Status:	
Appeal ID: 6678	Project Address: 539 SE 59th Ct
Hearing Date: 11/4/09	Appellant Name: Tad Everhart
Case No.: P-006	Appellant Phone: 503-239-8961
Appeal Type: Plumbing	Plans Examiner/Inspector: McKenzie James
Project Type: residential	Stories: 2 Occupancy: R-3 Construction Type: V-B
Building/Business Name:	Fire Sprinklers:
Appeal Involves: Alteration of/additional to an existing struct	ture LUR or Permit Application No.: 09-156160-RS
Plan Submitted Option: mail [File 1]	Proposed use: Single family residence

APPEAL INFORMATION SHEET

-				
То:	Tad Everhart			
From:	Alternative Technology A Edward Vranizan (chair) Peter Dusicka Joshua Klyber	dvisory Committee: Samir Mokashi (vice-chair) Aron Faegre	Kathy Bash Ron Hays	
RE:	Application #09-003 (Everhart) – Final Recommendation			
Date: Revised:	September 16, 2009 October 19, 2009

Everhart Passive House Retrofit 11/1/09

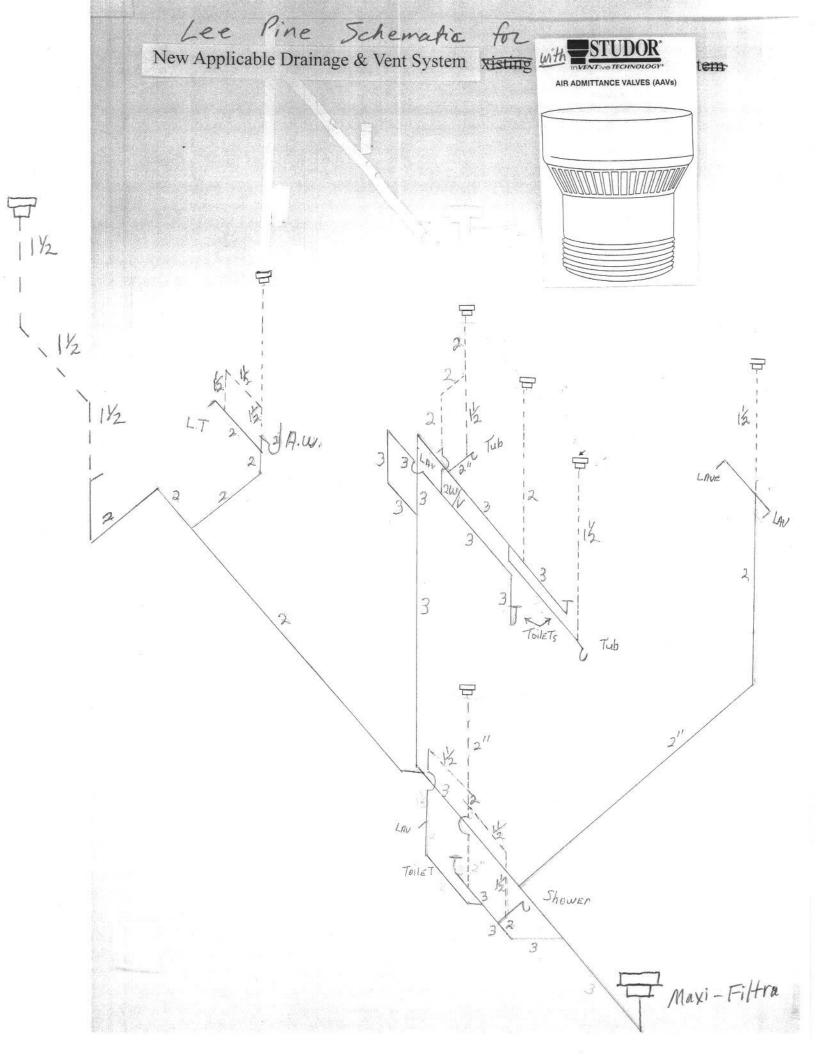
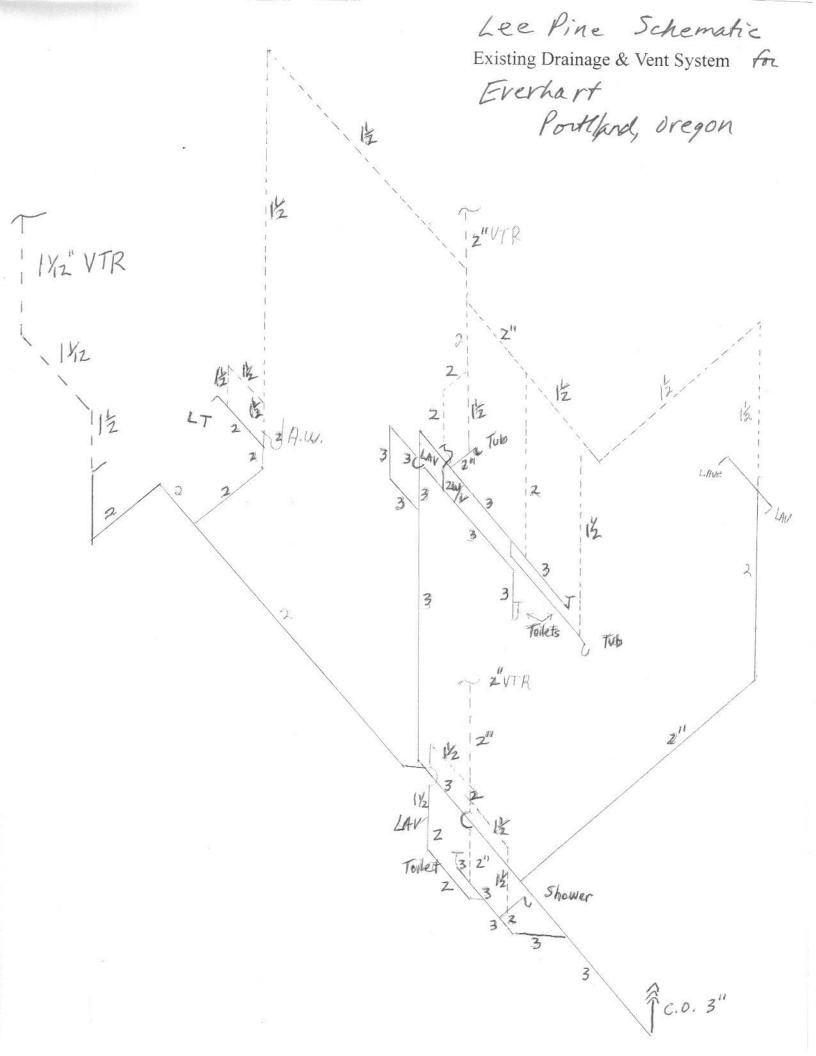
As the diagram indicates, the residence presently has a total of 3 vents that penetrate the roof. It would be quite simple to replace the piping penetrations of the roof and the piping that is presently in the walls, with the "Studor", (AAVs) "Air Admittance Valves". That is of course, with the approval of Local Authorities.

Since this residence has been established for a few years, it would require several more AAVs than would normally recommended by the manufacturer. The AAVs could be installed is several different locations. Each AAV would be readily available for viewing or replacement (if necessary), by having it installed in a "in wall" mounting box, with a removable grill. In the case of the Laves, these could be mounted above the "P-Trap" arm, or for the kitchen sink, above the drainage tee & "P-Trap" arm". No penetrations would be required for the new system and removal of the existing vent system could be easily handled during the remodel.

Allowing for the difference between the manufacturers specifications for air flow and the UPC specifications for the same, I would hope to at least see a compromise between the two. In addition, as indicated in the information and specifications brochure; a back-pressure positive relief (Maxi Filtra) for the street sewer system; could be installed on the outside cleanout, through the use of a "Y" branch ftg., and a male or female adapter with a riser to prevent any "backfill" from clogging the device.
